Colours Upgrade Report The Castles of King City Print Date:25-Oct-16

Phase North Model Eden (50-07) Elev B MOD

Model Eden (50-07) Elev B

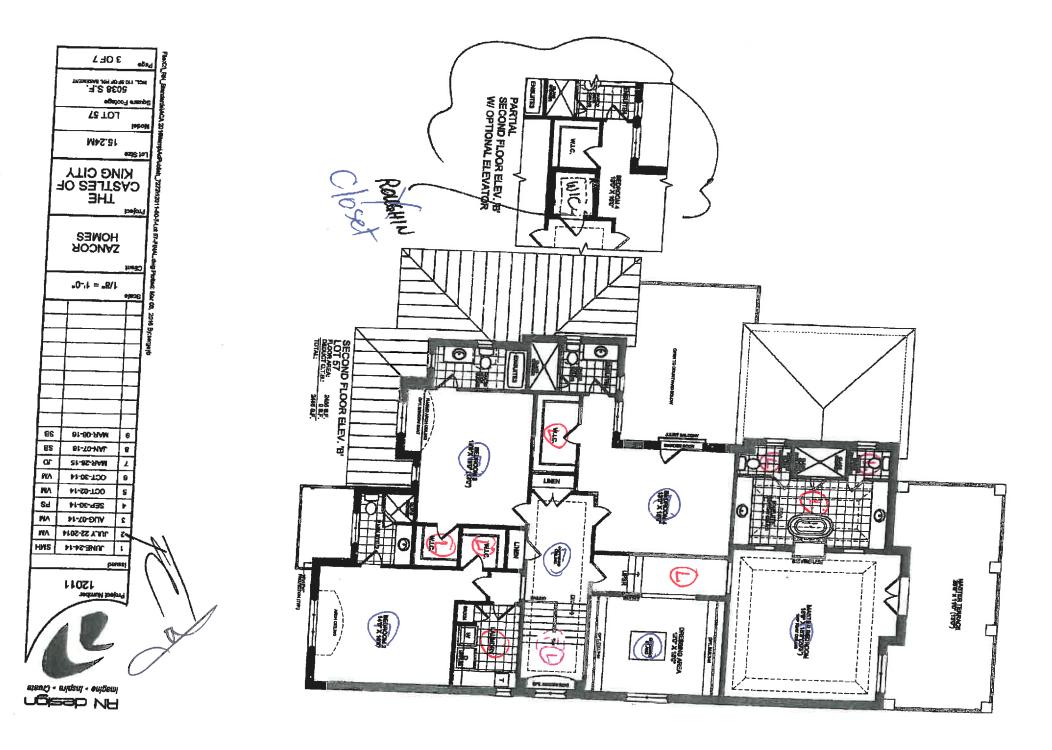
STRUCTURAL CHANGES - BECTRICAC - RAILINGS. - TRIM. - ELEVATOR ROUGHIN DELETED - PLUMBING

3929 STRUCTURAL LED POTLIGHTS - Locations as per sketch, standard lights to rem MASTER BED - 6 & 2 SPA ENSUITE - 2 MASTER WATER CLOSET - 2 & 2 MASTER SHOWER - 2 DRESSING AREA - 10 MASTER HALL - 4 BEDROOM 4 - 6 & 3 BEDROOM 4 CLOSET - 2 ENSUITE 4 - 2 ENSUITE 4 SHOWER - 1 UPPER HALL - 6	ain as per sketch 732
STAIR LANDING - 2 BEDROOM 3 - 6 ENSUITE 3 - 2 ENSUITE 3 TUB - 1 BEDROOM 2 - 8 ENSUITE 2 - 2 ENSUITE 2 SHOWER - 1 LAUNDRY - 4	
4844 STRUCTURAL STRUCTURAL CHANGE: CHANGE DELETE ELEVATOR ROUGH IN and INSTALL CLOSET WITH SIN SHELVING ON MAIN FLOOR AND SECOND FLOOR	GLE DOOR AND WIRE
4845 STRUCTURAL ELECTRICAL CHANGE: CHANGE DELETE LED STRIPS LIGHTS FOR WINE FRIDGE (#3562)	849
4846 STRUCTURAL PLUMBING CHANGE: CHANGE DELETE WATERLINE FOR COFFEE MAKER (#3598)	849
4847 STRUCTURAL RAILING CHANGE: CHANGE DELETE UPGRADE 5 RAILINGS (#3601) ******NEW RAILING STYLE TBD	849
4848 STRUCTURAL CHANGE: CHANGE DELETE UPGRADE 3B TRIM (#3602) ***INSTALL UPGRADE 2 STEP CASING & BASEBOARDS	849

4849 STRUCTURAL CHANGE: CHANGE INSTALL ELECTRICAL CHANGE: INSTALL ELECTRICAL OUTLETS AND VACUUM OUTLETS IN THEIGHT ***DO NOT INSTALL IN BASEBOARDS AS PER #3603	STANDARD LOCATIONS AND 849
4850 STRUCTURAL ELECTRICAL / STAIRS CHANGE: CHANGE DO NOT INSTALL ROUND STAIR LIGHTS IN STIARCASE AS PER	#3610
4851 STRUCTURAL PLUMBING CHANGE: CHANGE DO NOT INSTALL POT FILLER (#3612)	849
4852 STRUCTURAL ELECTRICAL CHANGE: CHANGE DO NOT INSTALL OUTLET FOR COFFEE MAKER (#3793)	849
4853 ELECTRICAL ELECTRICAL ADDITION: ADDITION INSTALL 20 LED POTLIGHTS AS PER ATTACHED SKETCH	849
4854 STRUCTURAL NO FUTHER STRUCTURAL CHANGES.	849
